114.8 Medium Dependent Interface (MDI)

114.8.1 MDI mechanical interface for 1000BASE-RHA

Figure 114–2—Duplex POF cable splitting and connection to the 1000BASE-RHA MDI receptacle

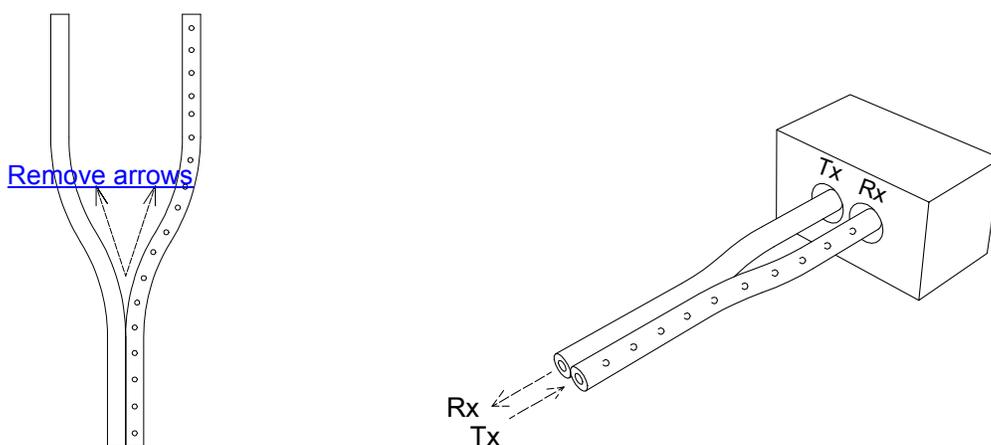
The 1000BASE-RHA MDI receptacle connector vendor shall properly clearly indicate the minimum split length needed for a suitable connection. Left side of Figure 114–2 illustrates the duplex POF cable splitting and the right side the fiber cable connection to 1000BASE-RHA MDI receptacle.

One of the jackets of the duplex POF cable shall have marking. A possible marking is illustrated in Figure 114–2. Such marking can facilitate installation when the optical transmitters of the link are off. There may be specific application marking requirements ~~are application specific, and shall follow the requirements in IEC 60794-2-41.~~
